DEPARTMENT OF THE NAVY
SOUTHWEST DIVISION
NAVAL FACILITIES ENGINEERING COMMAND
ENVIRONMENTAL DIVISION
1220 PACIFIC HIGHWAY, RM 18
SAN DIEGO, CALIFORNIA 92132-5181

M60050.000935
MCAS EL TORO
SSIC # 5090.3

5090
Ser 09E/641
April 27, 1995

Total Dissolved Solids (TDS) Increase Impacts to Water Usage

FIGURE
SIMULATED GROUNDWATER
PATHLINES FROM SHALLOW
TCE PLUME AFTER 20 YEARS
ALTERNATIVE 1
MCAS EL TORO
GROUNDWATER MODELING REPORT

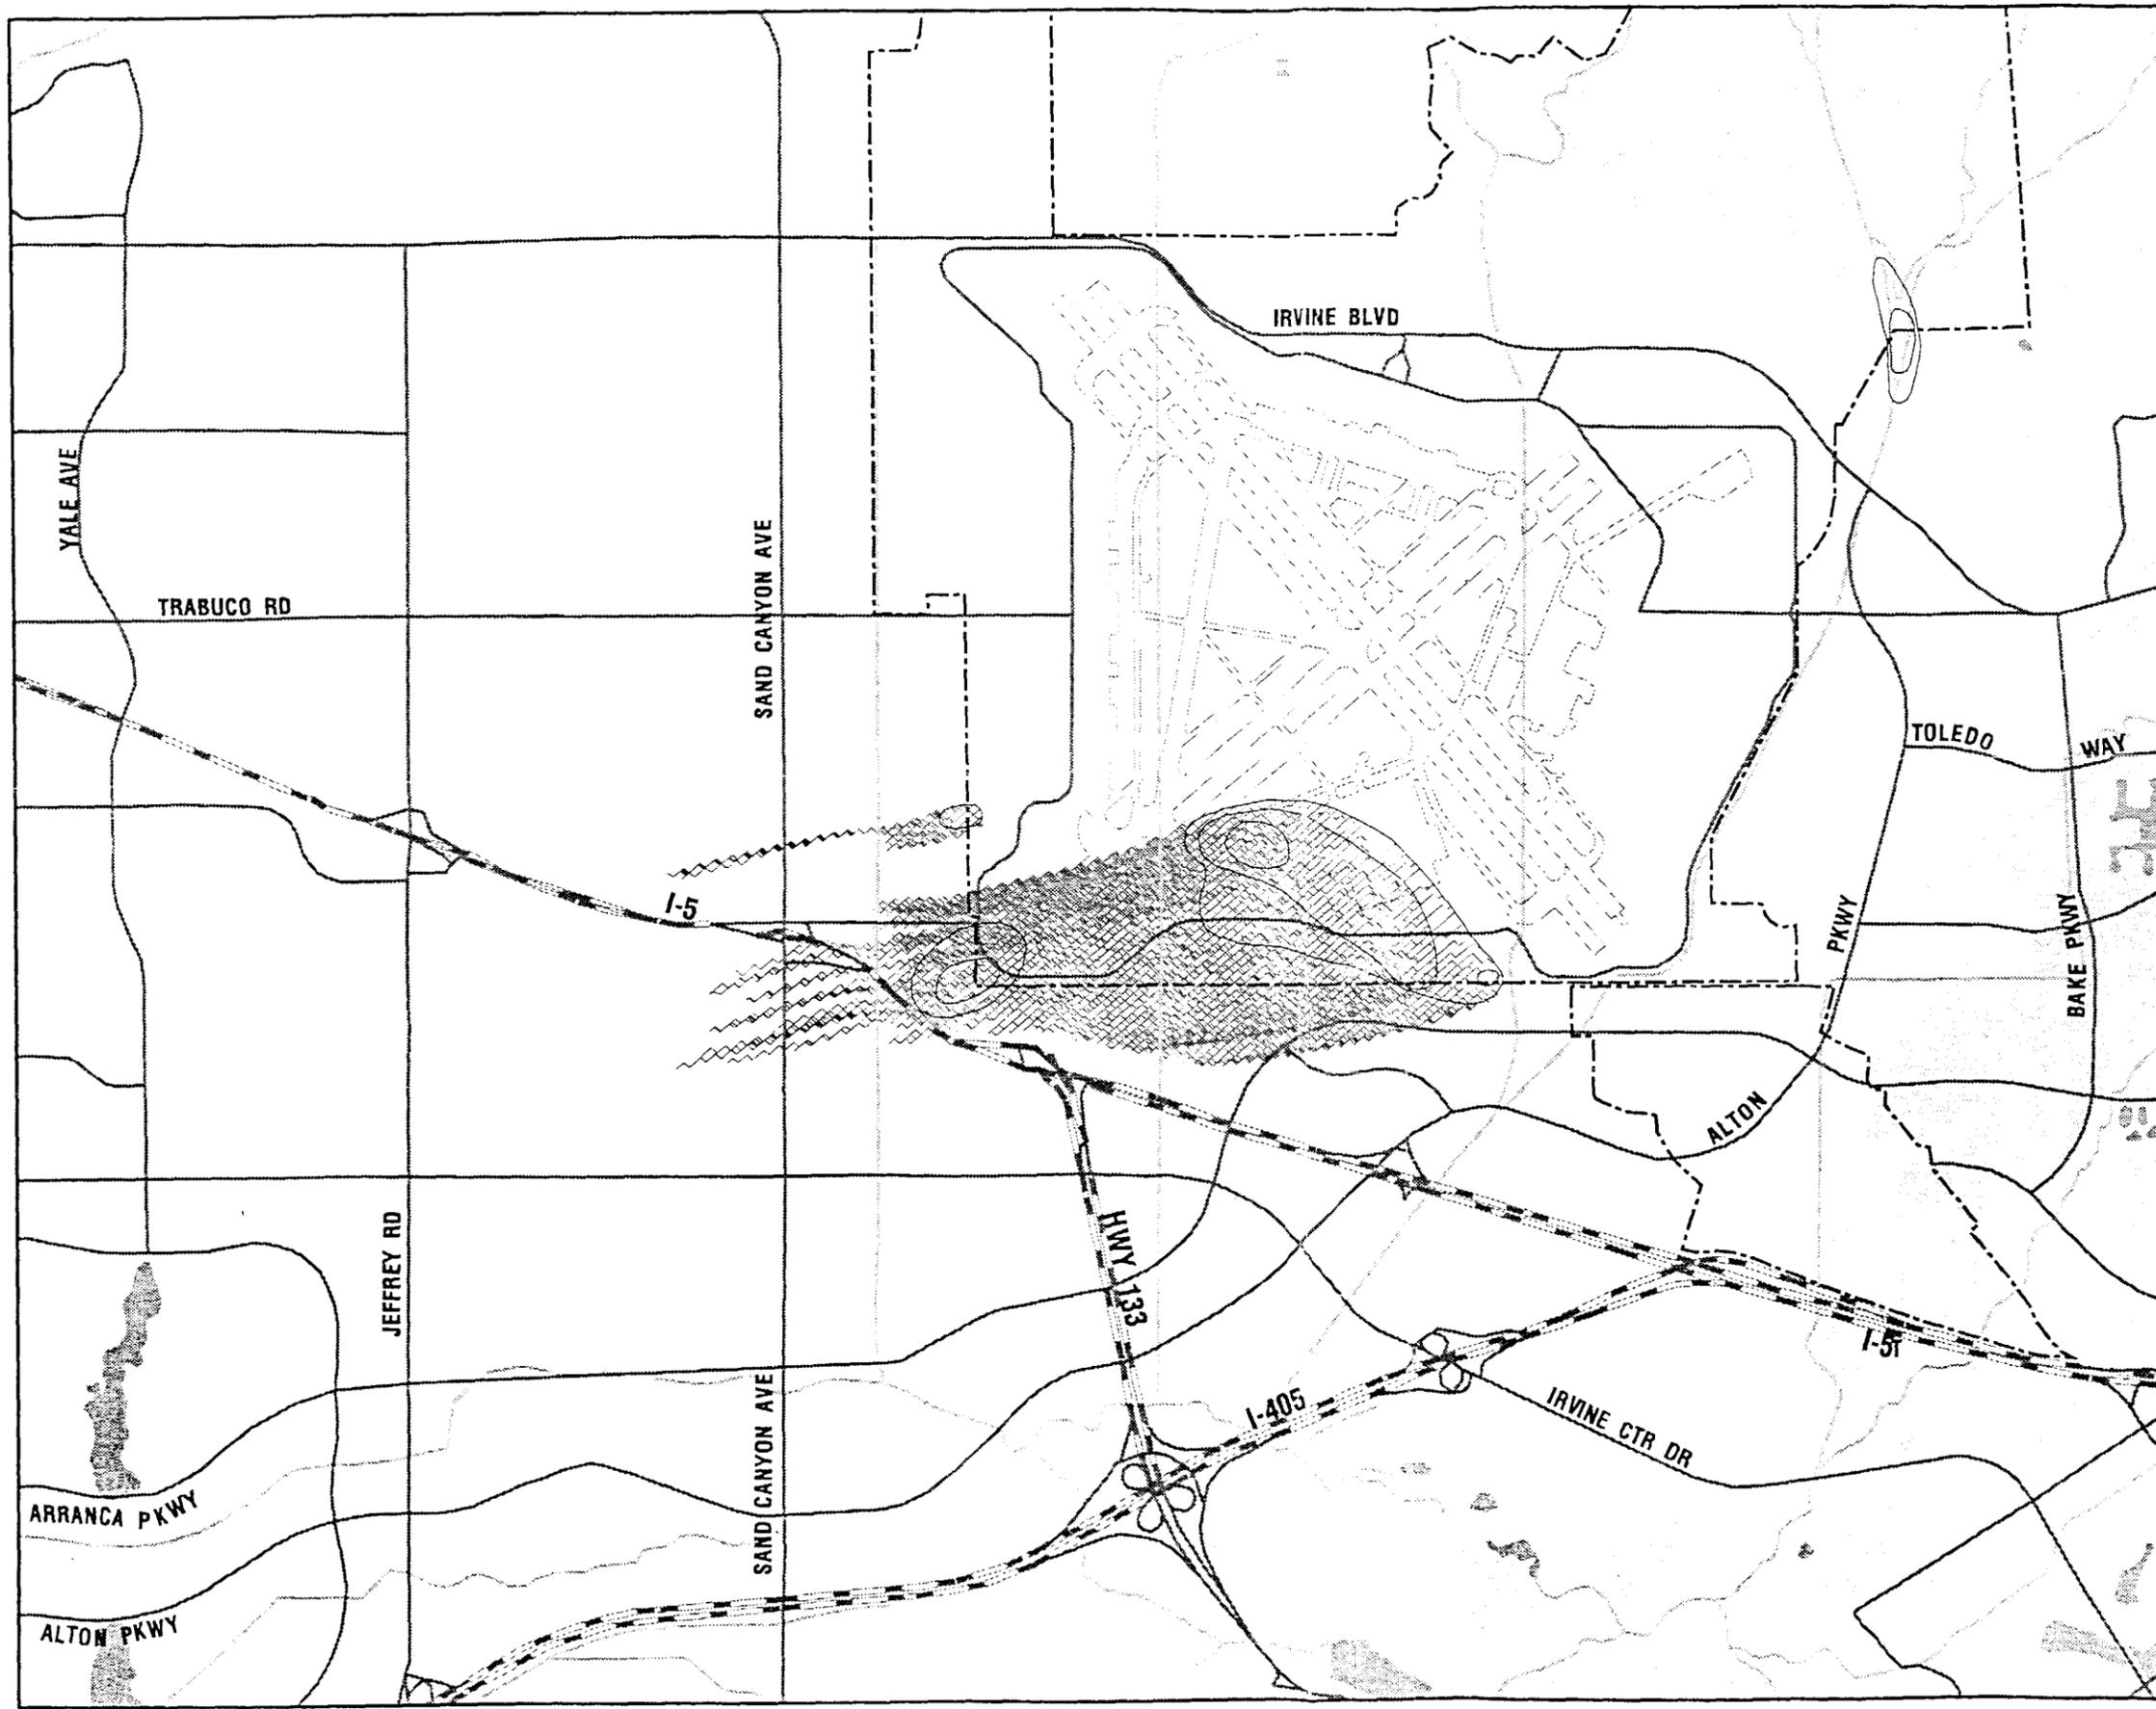
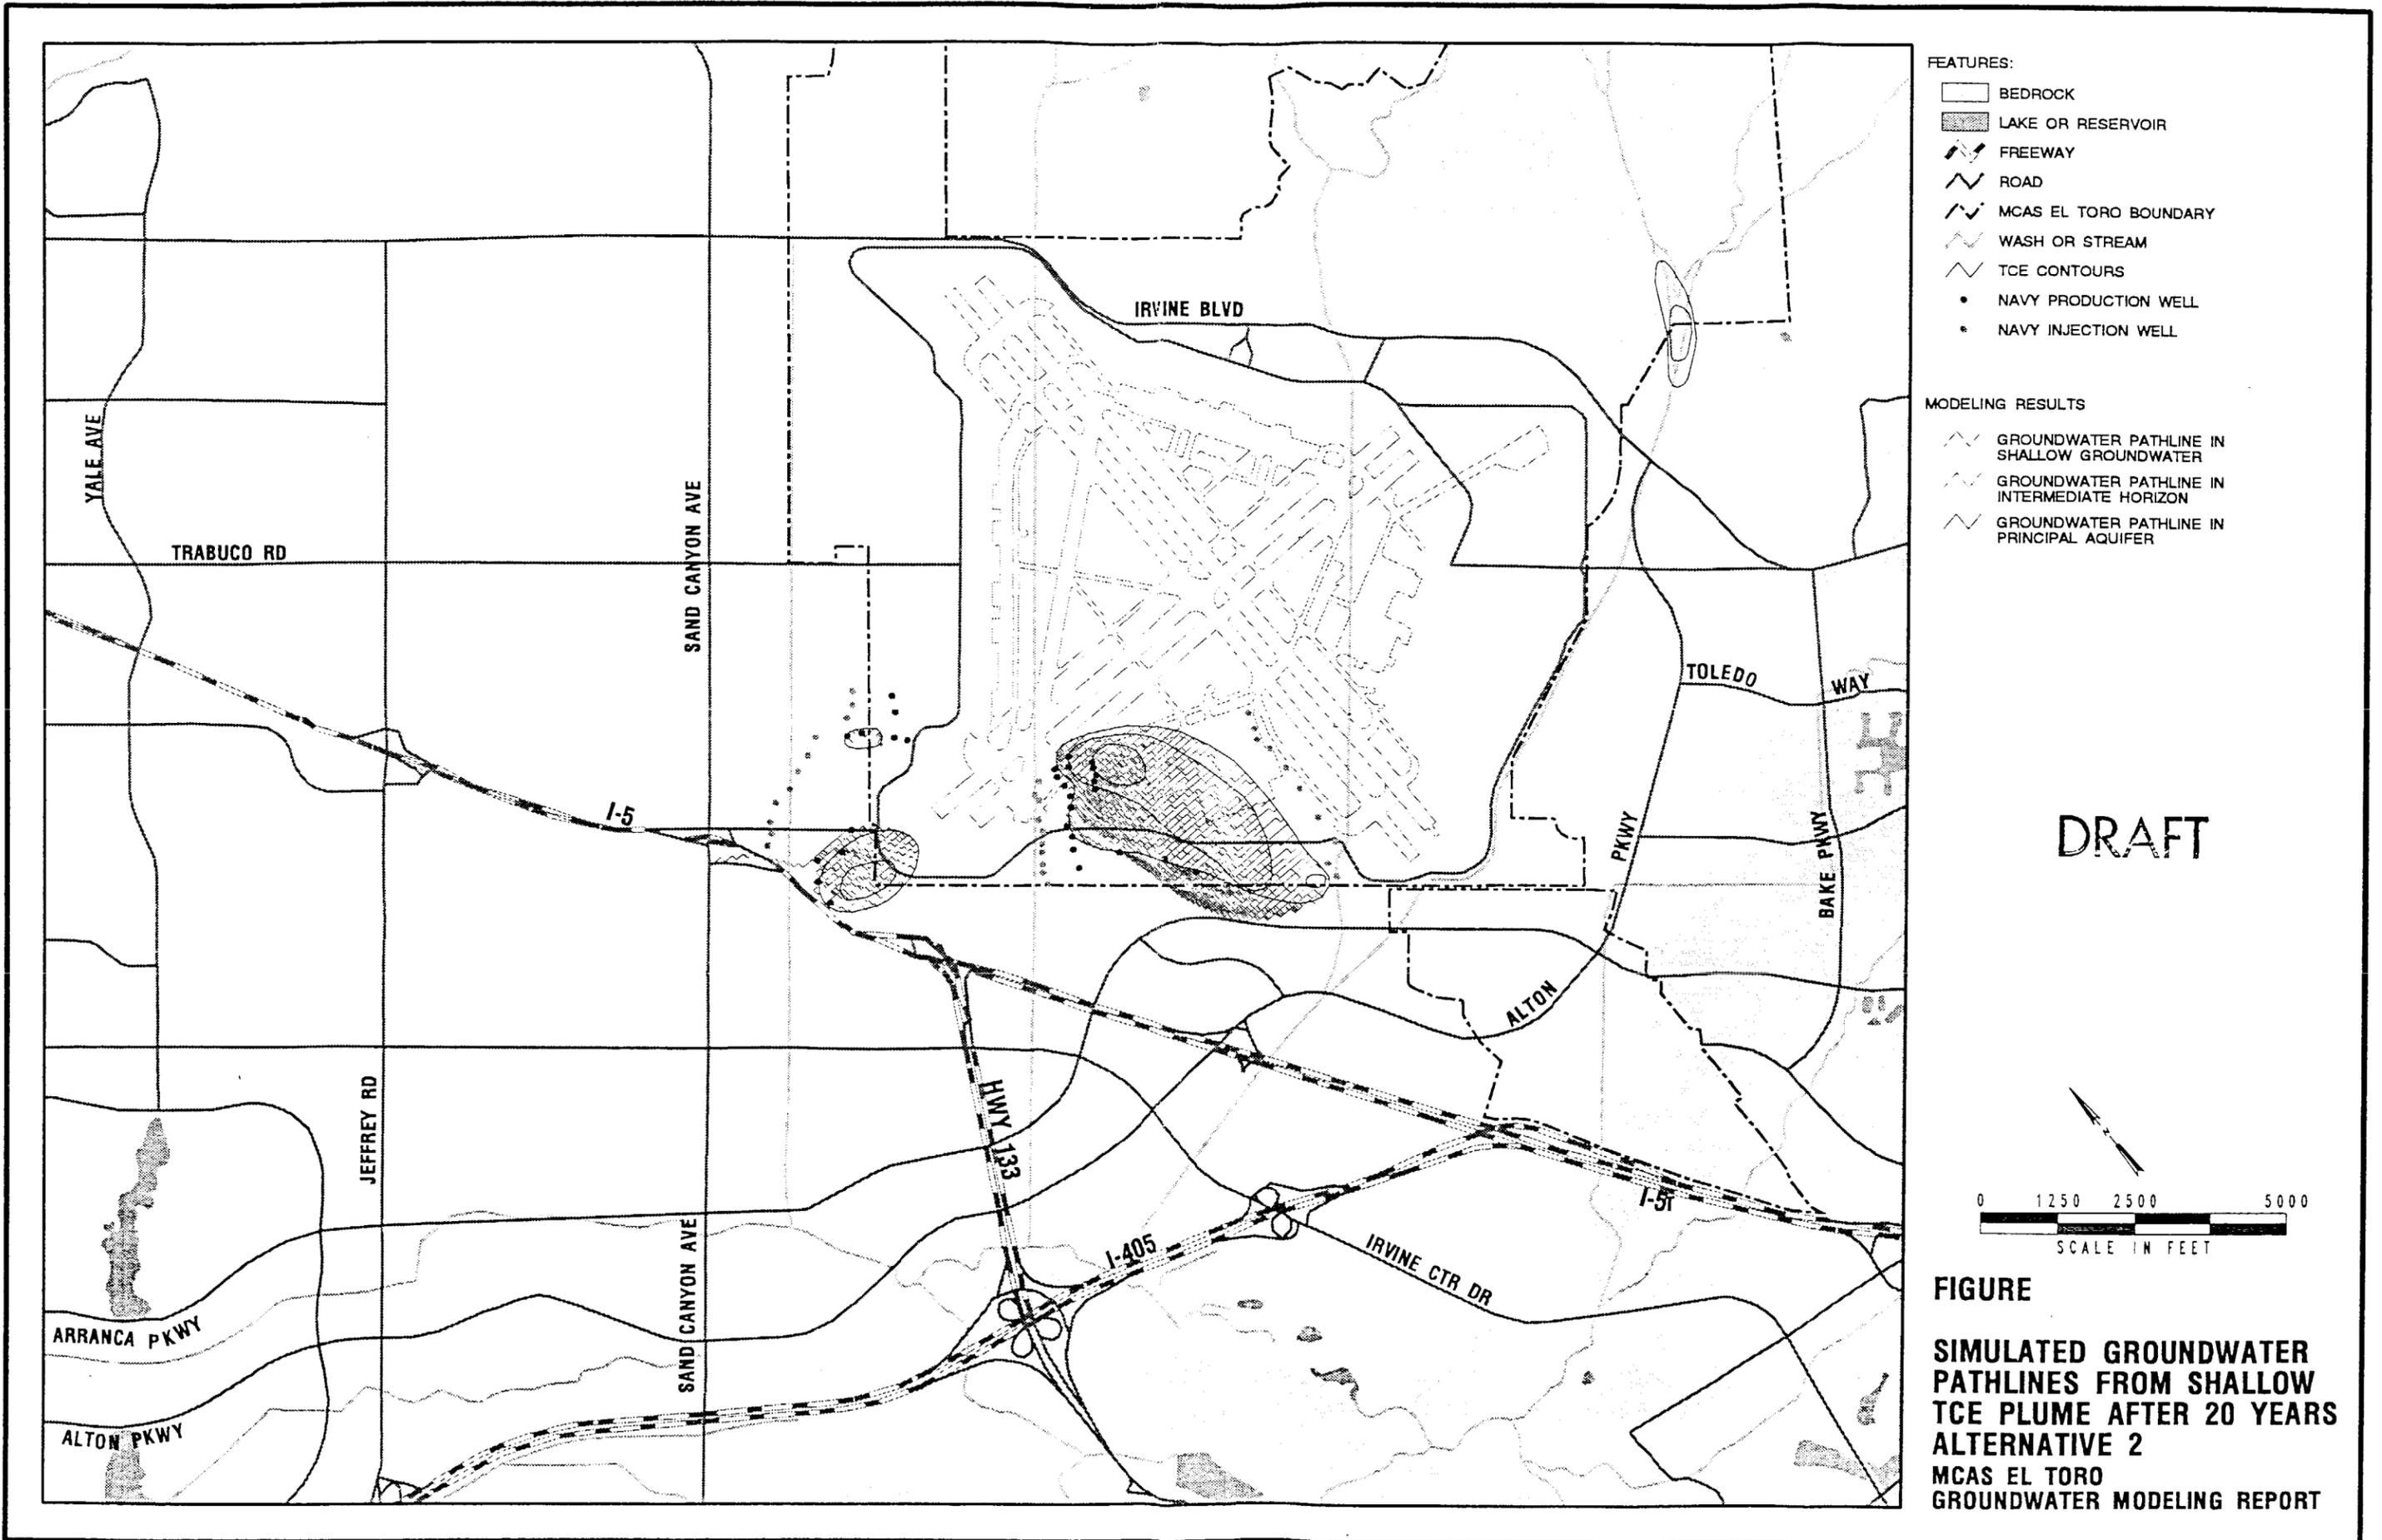
At the April 13 meeting, 20 year simulated TCE plume groundwater pathlines for the shallow groundwater (enclosure 1) and principal aquifer (enclosure 2) were presented. Both sets of figures model Alternative #1 (No Action), Alternative #2 (Independent DON stand-alone system), and Alternative #3 (Irvine Desalter Project). Although the simulations are for TCE particle tracking, TDS particle tracking would be similar. Even though both Alternative #2 and #3 are improvements over the No-Action scenario, the modeling clearly indicates that Alternative #2 controls particle migration much better than

Alternative #3. This comparison is most evident near the southwest boundary of the Marine Corps Air Station (MCAS) El Toro where Alternative #3 allows significant migration of low quality shallow groundwater into the principal aquifer; refer to enclosure (1).
